## Summary of electronics Meeting of February 11, 2002

In this 1-hour shortened meeting, a discussion was made of the five K-State Run 2b projects: L0-1 and L2-5 digital jumper cables, junction, adapter and “purple” cards will be discussed in that order, concentrating on relevant comments and decisions.

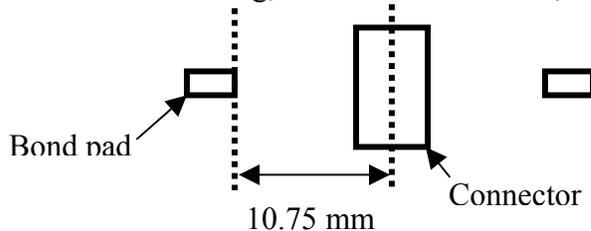
- 1) The goal for the digital jumper cables was to distribute L0-1 and L2-5 cables of varying lengths to Honeywell, (a DOE Lab) and to Basic, Inc. (a private company). Details were given in handouts and files e-mailed to video-conferencers. Everything appeared in good shape except that no money is in place. The Interlab work order (IWO) transfer had been converted to a P.O. by Fermilab, which doesn't work. Basic was to be paid by an MOU to K-State, also not in place.
- 2) Marcel raised the point that the cable ends near the hybrid may require redesign. After the meeting, I talked to Mike Utes, and we measured the following picture:

From the center of the connector to the inside edge of the bond pad is  $10.75 \pm 0.1$  mm by measurement on a 5X life-size drawing. However, it is 11.5 mm from the connector center to the edge of the DJC. Several folks stated that this is too long. After investigating, Noel stated that reducing 11.5 to 10.5 mm was easy, but more was quite difficult. However, there are wire bonds on both sides, and the body of the cable can just as easily flop down onto a wire bond on the right-hand side as can the edge of the cable wreck a wire bond on the left-hand side. Yours truly believes that we need a physical step or some other way, such as potting, to protect bonds on both sides.
